ADDENDUM NO. 8

WL-100 AREA ELEVATED STORAGE TANK PROJECT

NORTHWESTERN WATER AND SEWER DISTRICT

JANUARY 12, 2021

1. PLAN SHEET 1 of 4

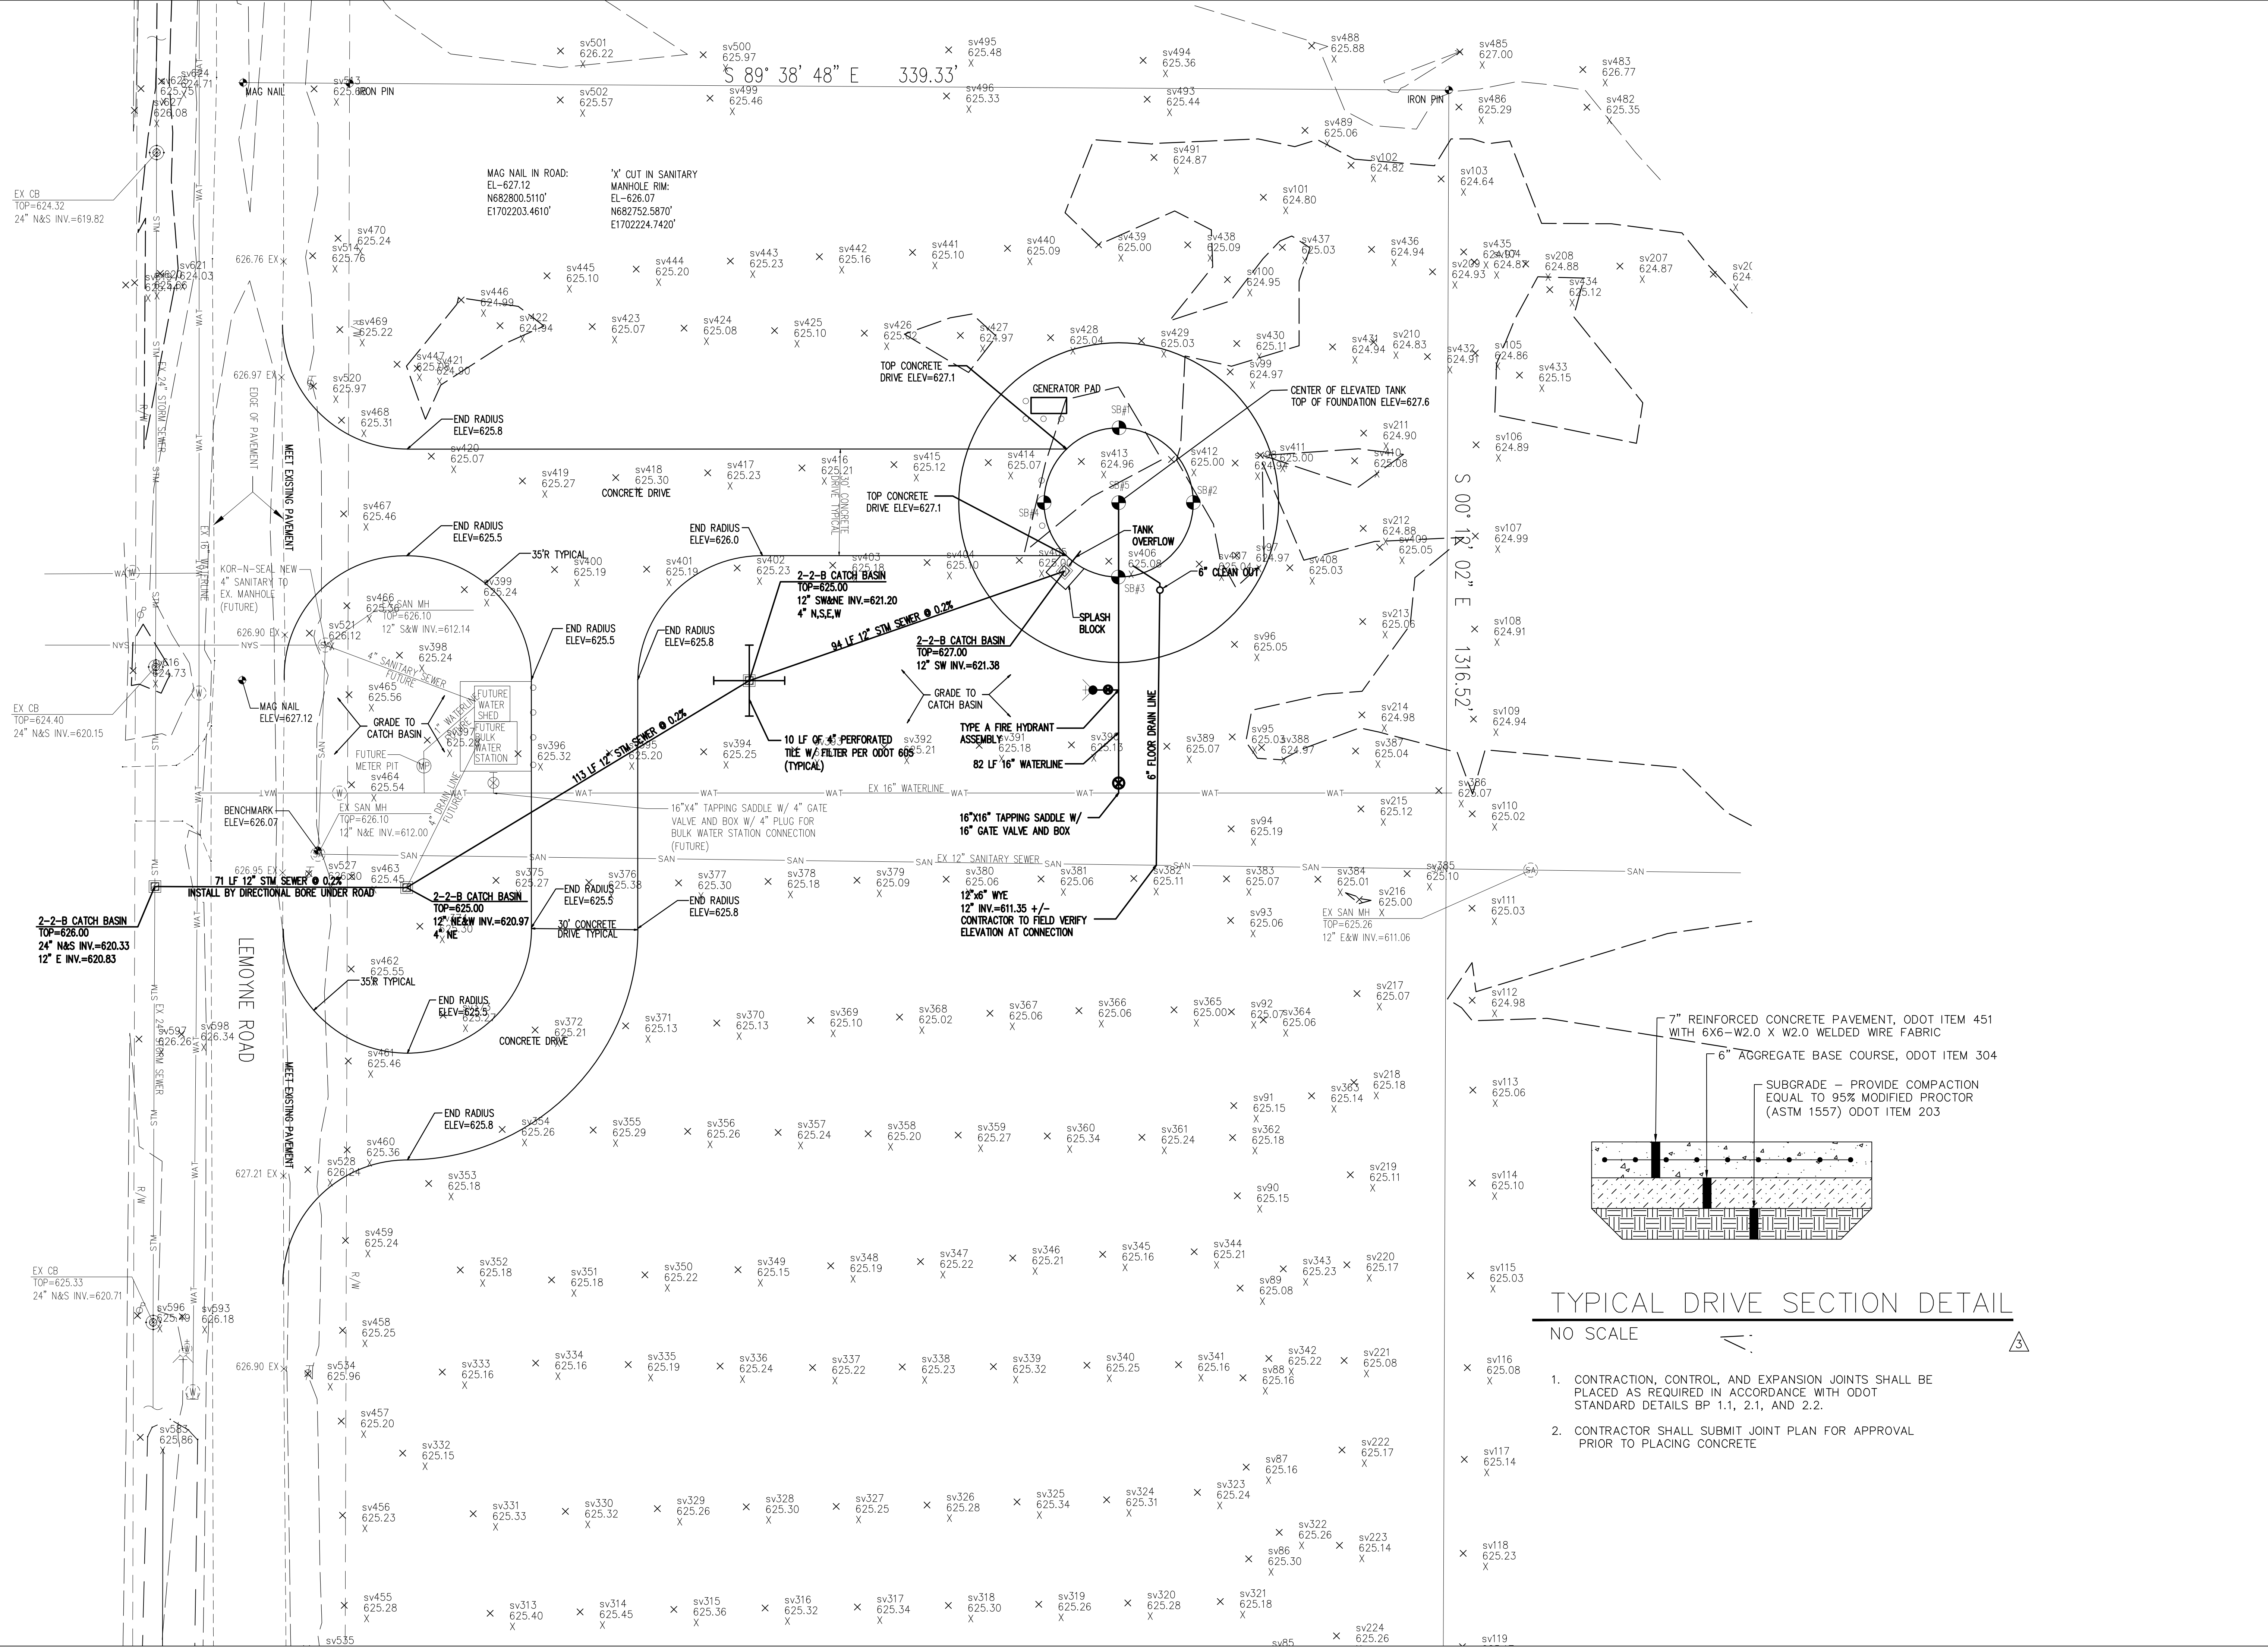
- a. As requested, the existing site grades have been added to this plan sheet. Revision is attached.
